Bates West Flooring Replacement Project

University of South Carolina
Project Number: 50003340-2
Project advertised: March 14, 2019

ADDENDUM NO.2

April 2, 2019:

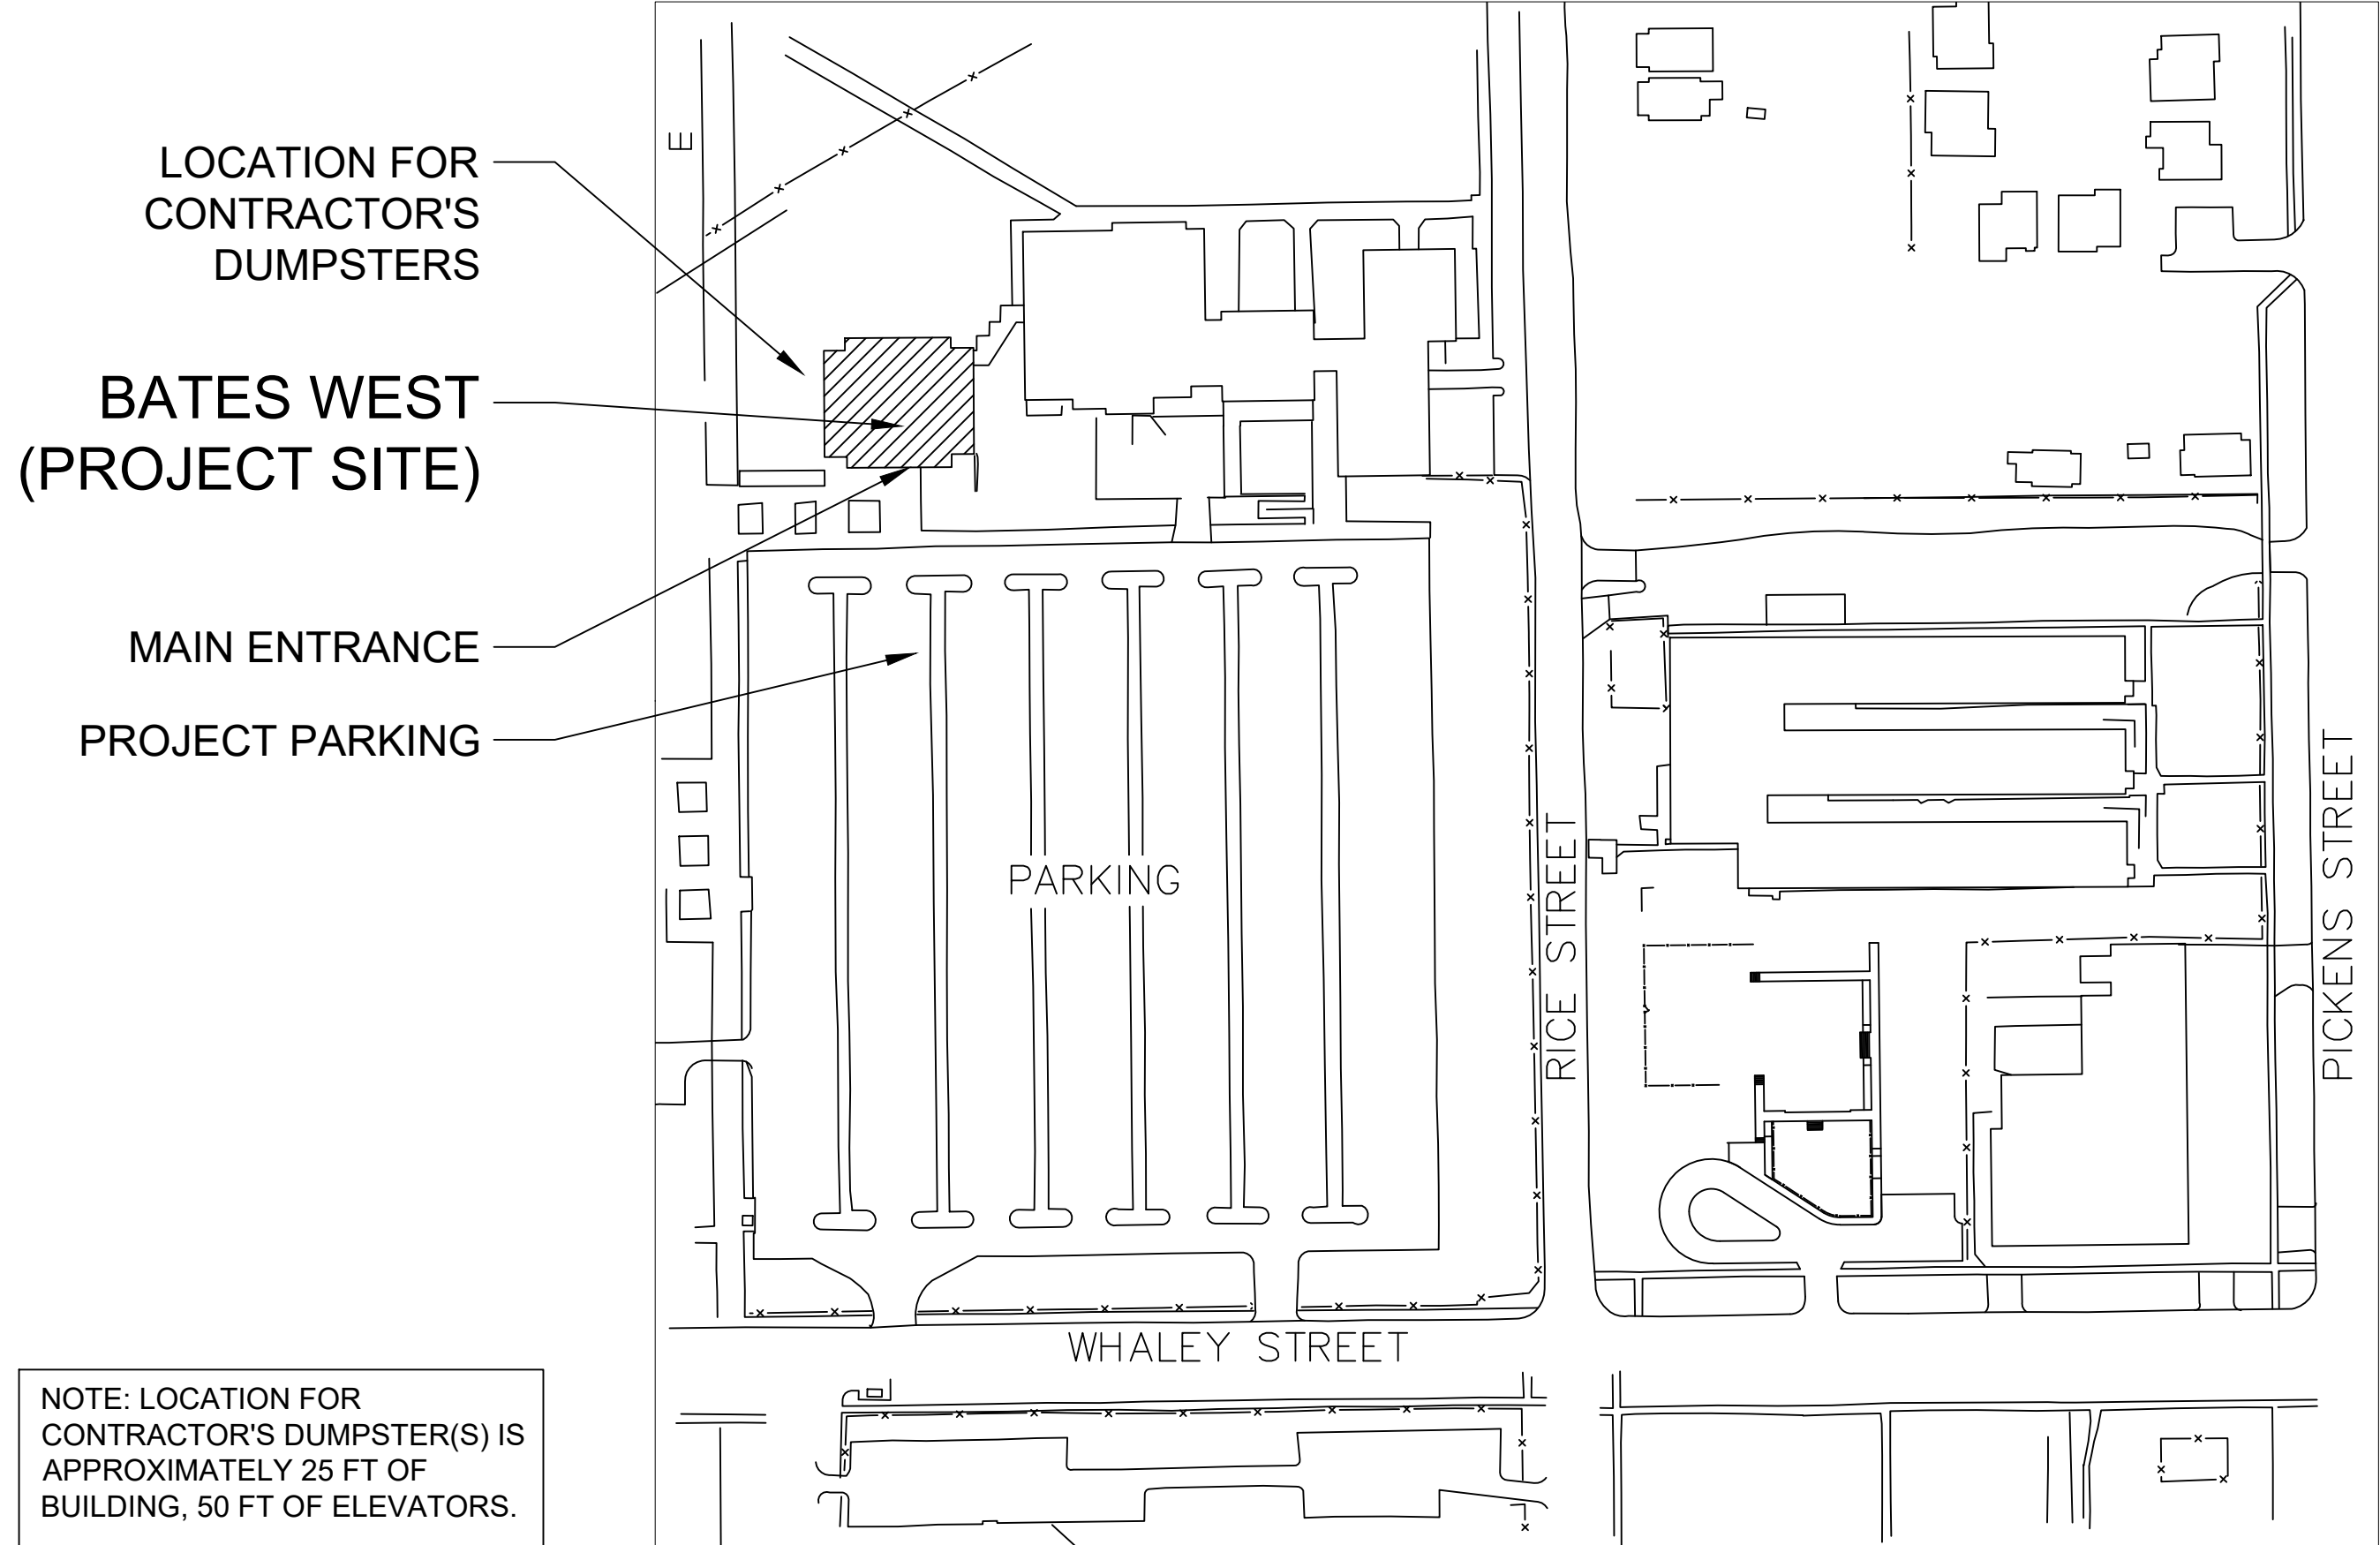
4. Provide approved location for dumpsters.

6. When covering existing 4" base in hallways with 6" base it creates a void in the wall at the top. What will be acceptable on this?

Response: Refer to Site Key on Revised T1.1 for location details.

Response: Refer to revised drawing *ID2.3* and *Finish Schedule* on *T1.1* for revised scope.

ID0.1
1ST FL
DEMOLITION PLAN

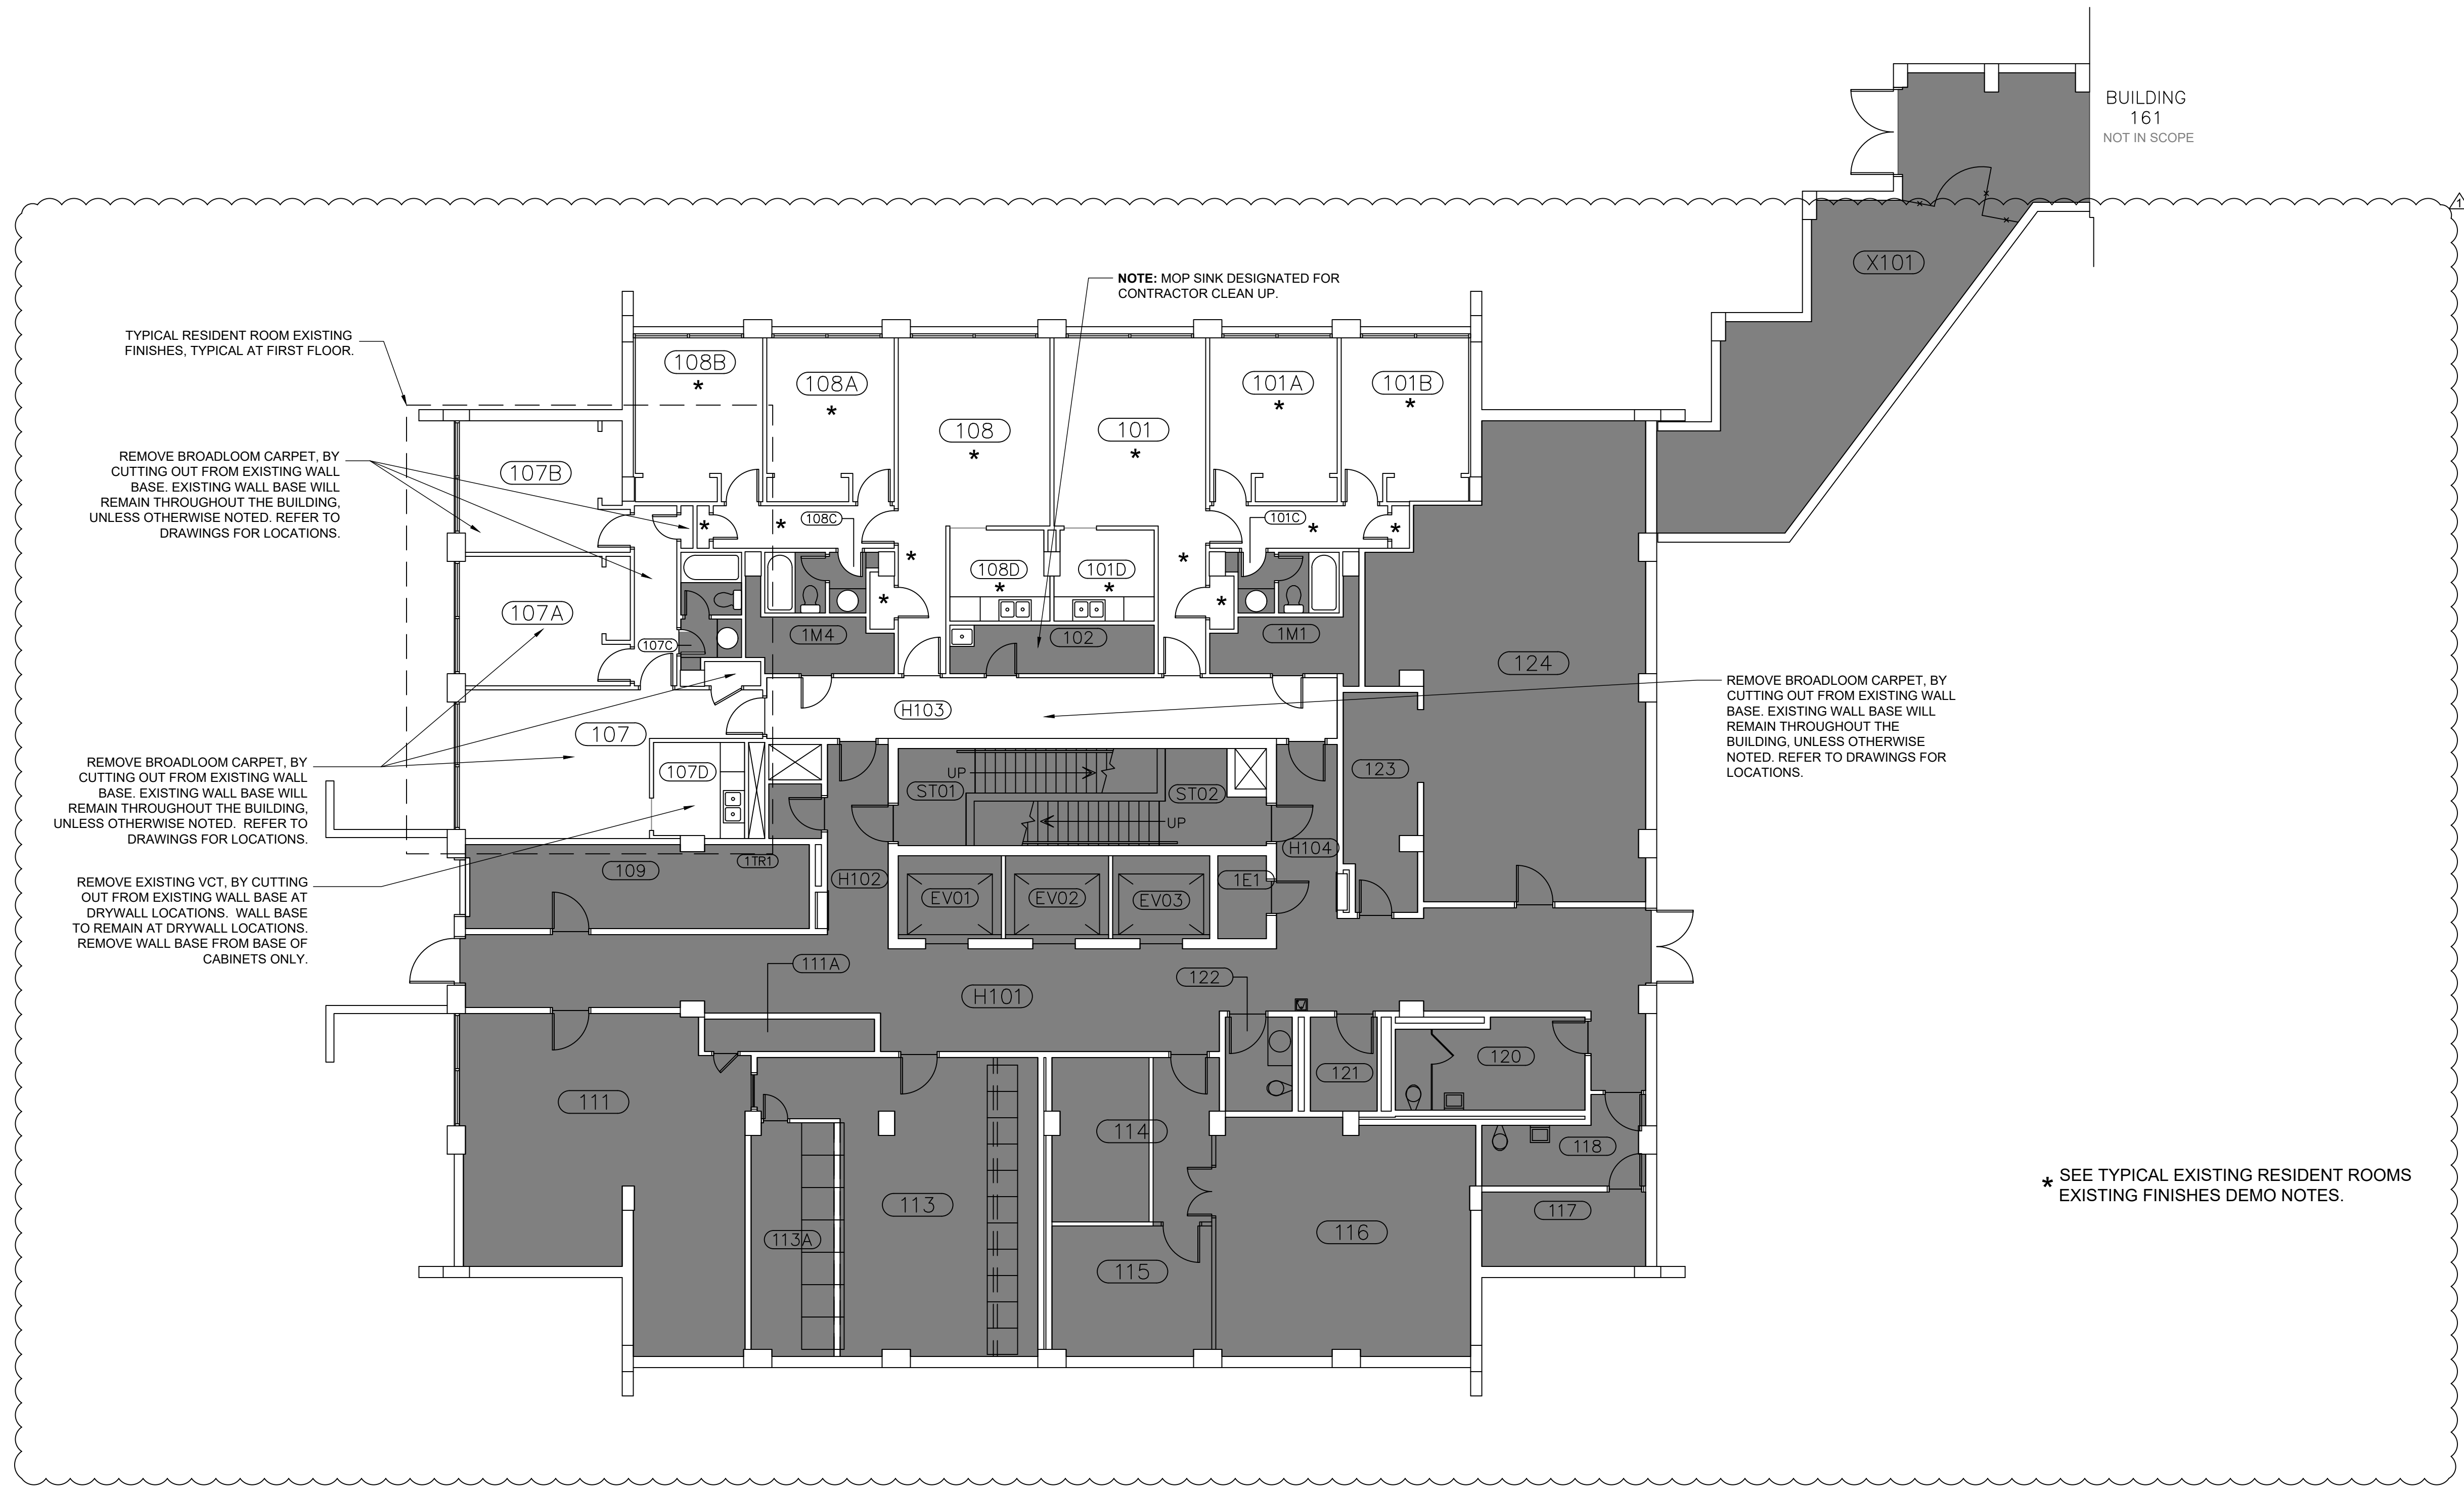
REMOVE BROADLOOM CARPET, BY CUTTING OUT FROM EXISTING WALL BASE. EXISTING WALL BASE WILL REMAIN THROUGHOUT THE BUILDING, UNLESS OTHERWISE NOTED. REFER TO DRAWINGS FOR LOCATIONS.

REMOVE EXISTING VCT, BY CUTTING OUT FROM EXISTING WALL BASE AT DRYWALL LOCATIONS. WALL BASE TO REMAIN AT DRYWALL LOCATIONS. REMOVE WALL BASE FROM BASE OF CABINETS ONLY.

ID0.3
TYPICAL
RESIDENTIAL
FLOOR DEMOLITION
PLAN (FLOORS 3-14)

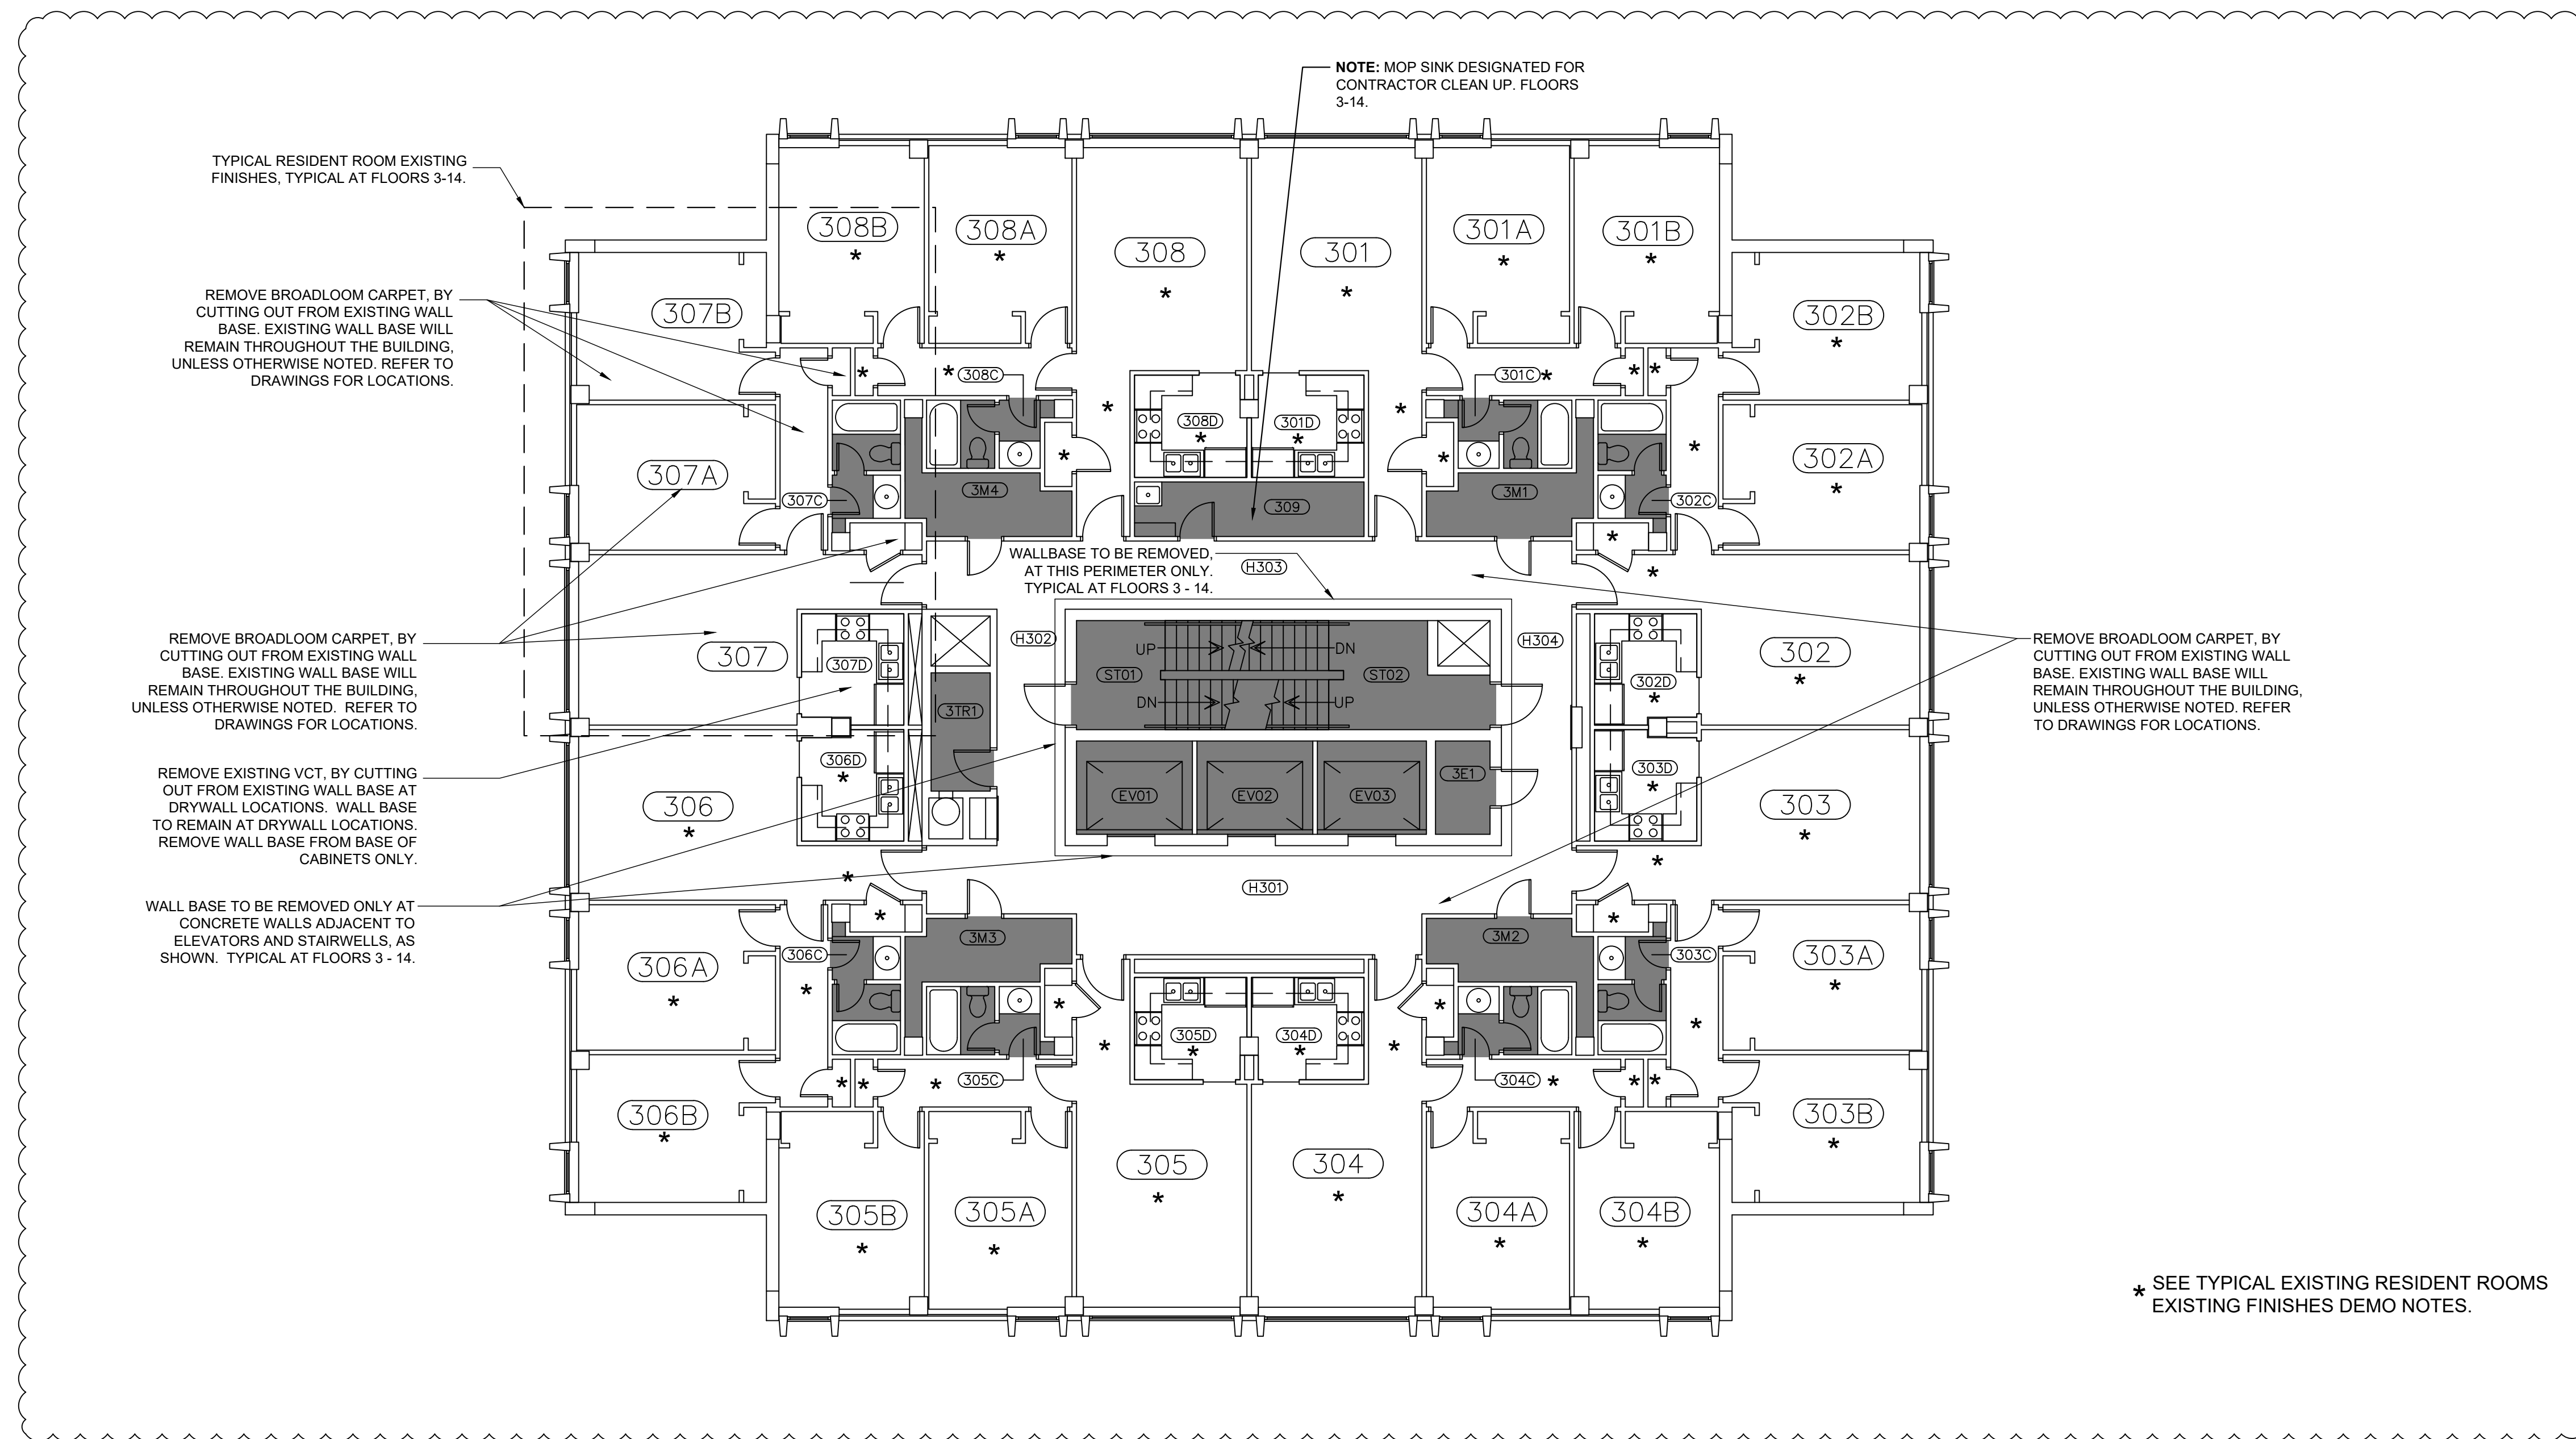
NOTE: AT LOCATIONS NOTED ABOVE, WALL BASE REMOVAL TO BE IN A MANNER NOT TO DISTURB PAINT ON WALL. GC WILL BE RESPONSIBLE FOR REPAIR/REPAINTING ALL AREAS DAMAGED DURING REMOVAL.
